UNITED STATES PATENT AND TRADEMARK OFFICE

10/562,203

| Office Action Summary | Application No. 10/562,203 | Applicant(s) CLEMENT ET AL. | |

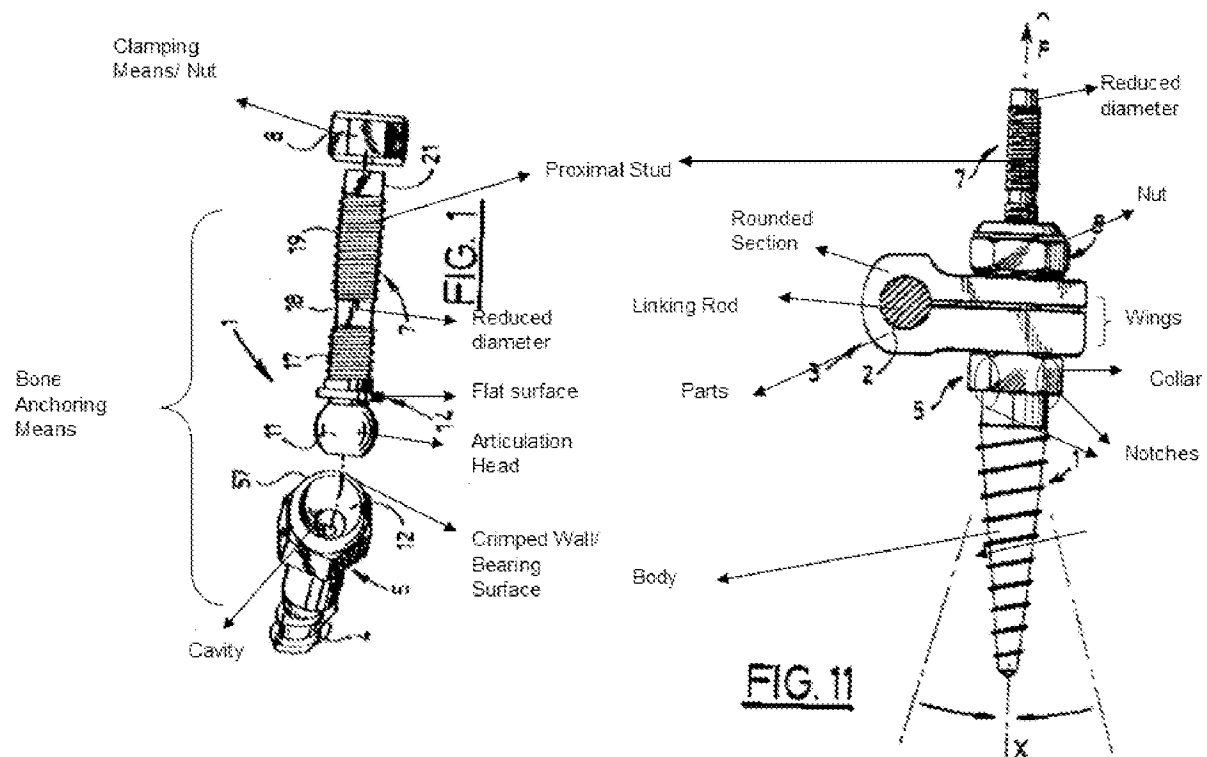
Regarding **Claim 1**, Taylor et al discloses vertebral osteosynthesis equipment, including bony anchoring members, intended to be connected to these anchoring members and to be attached to the vertebrae, parts for connecting linking rod to the anchoring members, and clamping means for locking the linking rod in said connecting parts; at least one anchoring member is of the polyaxial type, comprising one proximal stud articulated with respect to a body intended for gripping a vertebra; equipment characterized in that the proximal stud of said polyaxial anchoring member exhibits an articulation head in the form of a spherical cap; and said body of the other anchoring member comprises a cavity intended for accommodating this articulation head and a wall surrounding the cavity, the wall being crimped around said articulation head and shaped in order to provide a proximal form, at least partially hemispherical (see Col 5 lines 1-7, where the wall is crimped around the articulation head and see Figs below and see Col 2 lines 65-67, Col 3 lines 1-12, where the articulation head is polyaxial).

Regarding **Claim 2**, Taylor et al discloses vertebral the body comprises a proximal gripping portion enabling to hold said body when tightening said clamping means, this proximal gripping portion being formed of a collar exhibiting several radial notches (see Fig above, where two notches are circled, where from the Figs, the collar exhibits multiple notches across the collar).

Regarding **Claims 4, 11**, Taylor et al discloses at least one connecting part exhibiting a rounded section intended for surrounding a linking rod and two parallel drilled wings, the wings intended for engaging onto said proximal stud and for being clamped, the clamping means is capable to bear against a surface contained in said

polyaxial anchoring member; the distal wing of the connecting part exhibits a distal cavity (#10 see Fig 2) in the form of a spherical cap, which is of greater diameter than that the crimped wall, the connecting part being intended for resting against this crimped wall (#57 as seen in Fig 10) at of this cavity (see Figs above as well).

Regarding **Claims 7, 13, 15** Taylor et al discloses the stud exhibits a zone of reduced diameter, enabling to break its proximal portion after placing and clamping the nut (see Figs above and see Col 5 lines 31-42).

surface provided on the connecting part, whereas these flats surfaces are immediately close to one another when the connecting part is engaged on the proximal stud (see Fig above and Fig 10 and see Col 7 lines 8-20, where flat portions on the proximal stud and connecting part immobilize rotational movement).
